**NSLPP MEETING HELD ON 13/09/23****Attachments:**

ADDRESS/WARD: Land adjacent to 63 Willoughby Road, Crows Nest

APPLICATION No: DA 93/23

PROPOSAL: Installation and operation of a freestanding advertisement structure for the purposes of Council communication and third-party advertising

Figure 1: Proposed Advertising Panel

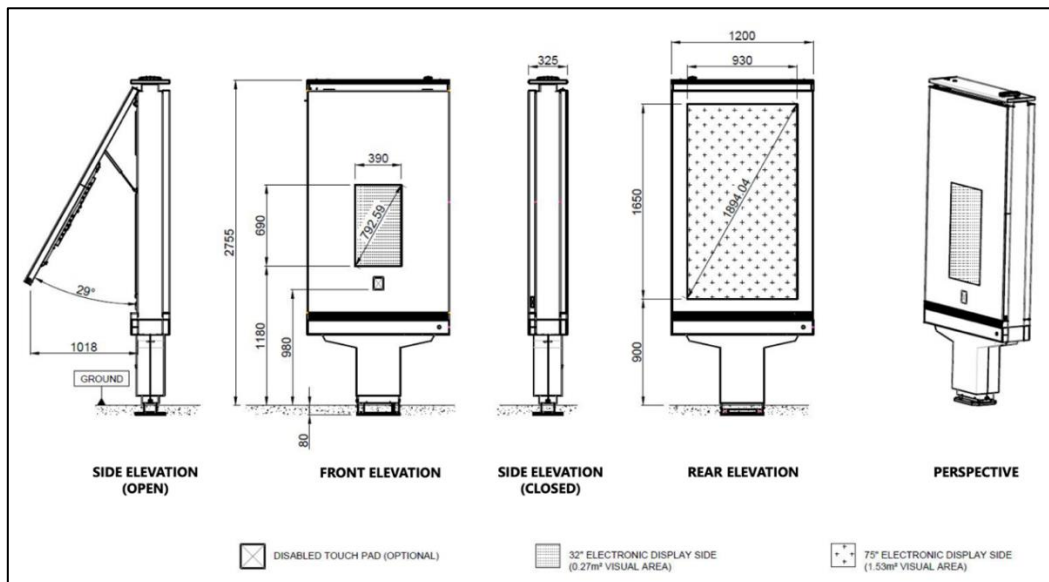
"The proposed advertising pillar will be a visual intrusion to the setting of the heritage item, particularly when brightly coloured content and/or dynamic advertising is displayed. It will draw attention away from the heritage facades and the established character of Ernest Place as a community place.

The proposed signage will visually detract from the architecture of the church by introducing visual clutter.

The proposed pillar is not integrated with the architecture of the church in any way. It is recommended that it be re-located away from the church.

*The proposal is **not** supported. It is recommended that the pillar be re-located into a position that is integrated into the proposed new community centre and car park away from the church.*

***Photo 1: View from across Willoughby Road looking towards Ernest Place
Location of panel shown in red***

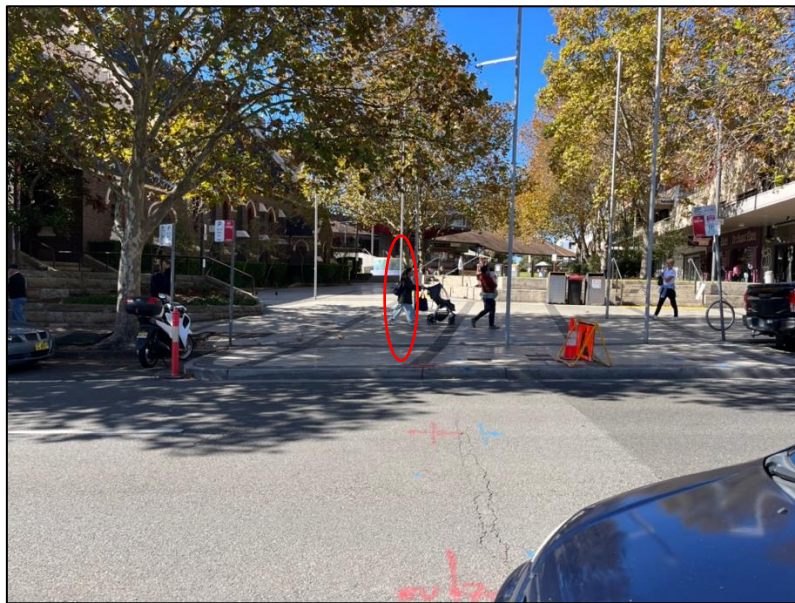
<p>The proposed panel is located at the end of the Ernest Place on a kerb that extends adjacent to the vehicular parking lane. The kerb extension acts as an informal pedestrian crossing for pedestrians travelling between Ernest Place and the western side of Willoughby Road.</p> <p>The Road Safety Assessment assesses notes that pedestrians walking westbound out of Ernest Place to cross Willoughby Road will have their sight lines of southbound travelling vehicles obscured by the proposed panel. <i>“This has the potential to result in pedestrians stepping out onto the road without realising a vehicle is travelling southbound resulting in pedestrian / vehicle conflicts”.</i></p> <p>The Road and Safety Assessment Report recommends:- <i>“relocate the proposed communication panel a minimum of 2.5m from the kerb to allow for adequate pedestrian sight lines to oncoming traffic.</i></p> <p>Unfortunately locating the panel further away may resolve sightlines but will render the panel even closer to the heritage listed church as well as the public open space (Ernest Place) and outdoor dining areas. It would also reduce pedestrian footpath widths and be in direct conflict with pedestrian path of travel.</p> <p>Accordingly, the site is not considered suitable for the proposed advertising panel.</p> <p>Motorist Sight Lines Willoughby Road is generally a straight road in this location and does not have any significant decision points on approach to the proposed panel. The major display side of the panel faces southbound traffic and is generally obscured by parked cars on approach. Therefore, the proposed panel will not adversely impact a driver travelling along Willoughby Road.</p> <p>Sight Lines for Motorcycle Parking Zone A motorcycle parking zone is located immediately to the north of the proposed panel which has the potential to block the sight lines for motorcyclists to oncoming northbound traffic when leaving the parking space. The sight lines available are presented in Figure 4 and Figure 5 of the Road Safety Assessment. It shows that a motorcyclist would be able to see to the raised pedestrian crossing which is located approximately 40m to the south while still within the parking lane. It is expected that northbound traffic would travel slowly over the raised pedestrian crossing such that 40m of sight line is sufficient for a motorcyclist to safely observe gaps in approaching traffic.</p> <p>It is considered that the panel has the potential to obscure pedestrian line of sight, resulting in pedestrians potentially stepping onto the road without realising a vehicle is traveling southbound. Accordingly, the location of the panel is not supported.</p>

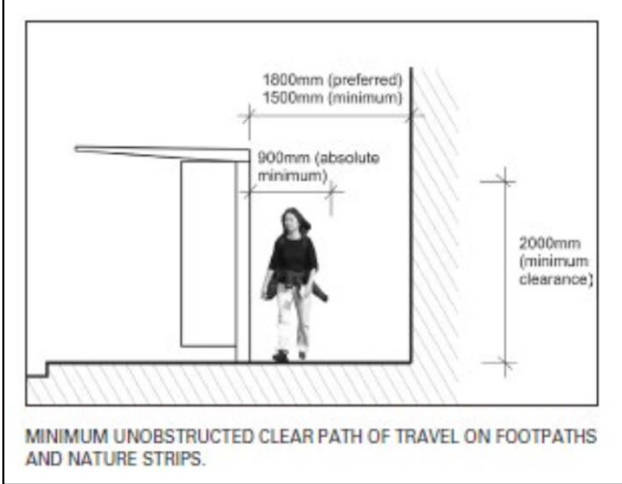
<p style="text-align: center;">Figure 6: Road clearance criteria Source: Transport corridor guide p.38</p>	
<p>3.2.2 Line of sight 3.2.3 Proximity to decision making points and conflict points 3.2.4 Sign spacing</p>	<p>Willoughby Road is generally a straight road in this location and does not have any significant decision points on approach to the proposed communication panel. The panel will not impact or obstruct the required driver sight lines.</p> <p>However pedestrians walking westbound out of Ernest Place to cross Willoughby Road will have their sight lines of southbound travelling vehicles obscured by the proposed communications panel.</p>	<p>No</p>
